E8362B-01C

S E R V I C E N O T E

E8362B PNA Series RF Network Analyzers

Serial Numbers: 00000000 thru 46999999

Figure 1

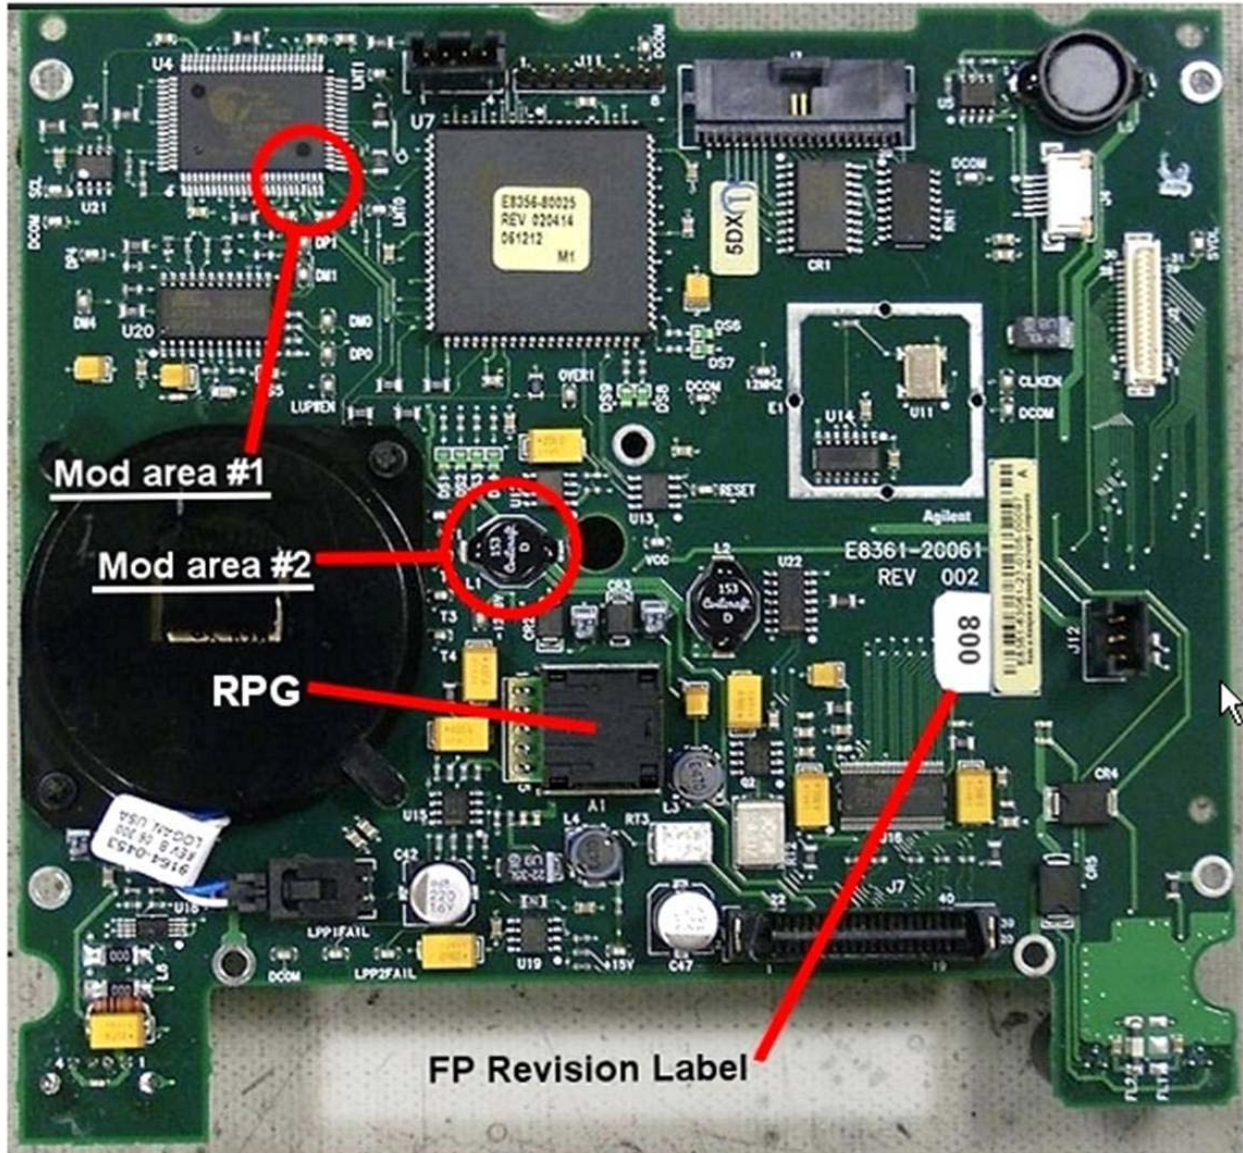
Refer to Figure 1 for the two modification areas to be addressed. Note that while this picture happens to show the FPI board completely removed from the front frame assembly, this is not necessary to perform the required modifications.

- Modification #1 consists of shorting two pins of U4 together with a small amount of solder.
- Modification #2 consist of removing L1.

Figure 2

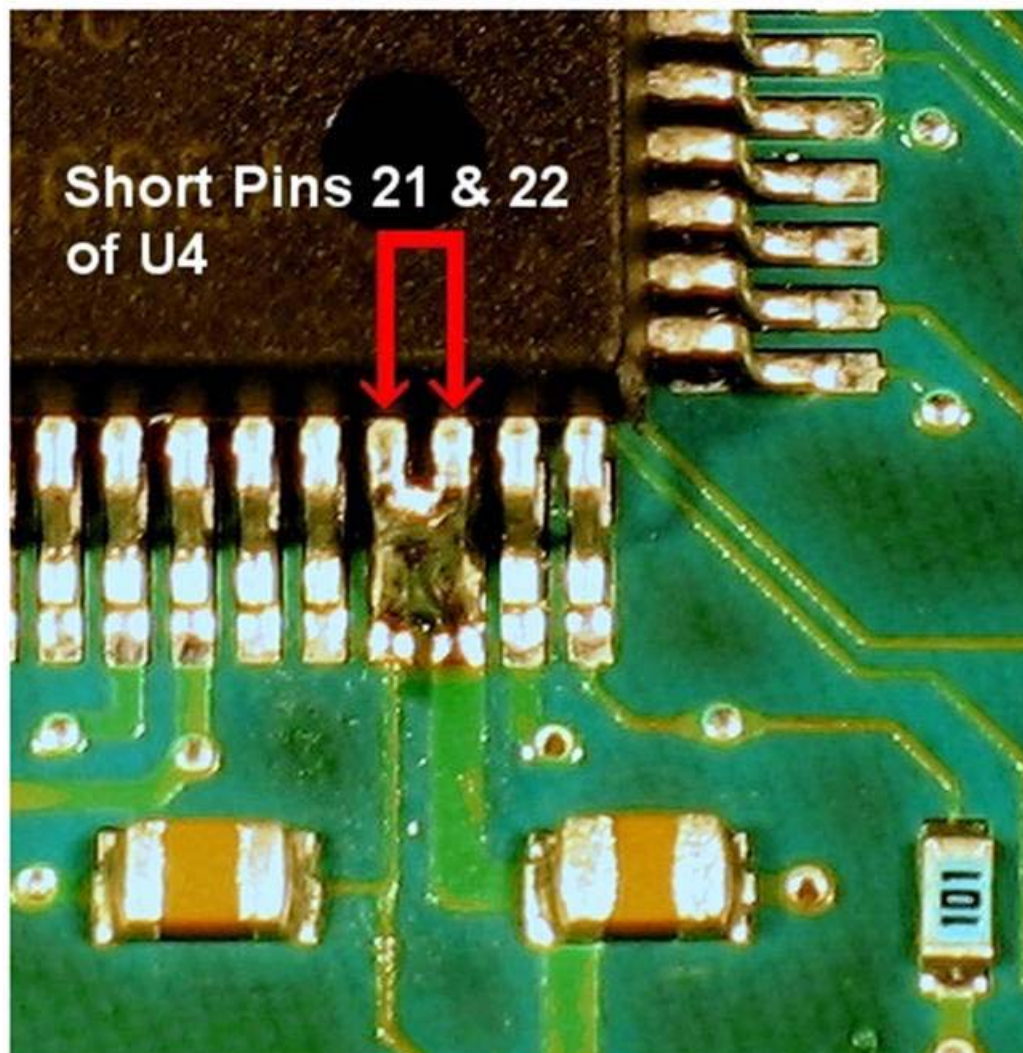
Carefully solder pins 21 and 22 together on U4. Refer to Figure 2 for the exact location. Use care so that no other pins are shorted. Use of a very fine tip soldering iron is recommended and a large work-task magnifying glass is very helpful.

Unsolder and completely remove the black surface mount inductor L1 from the front panel assembly board. This is no longer needed and can be discarded.
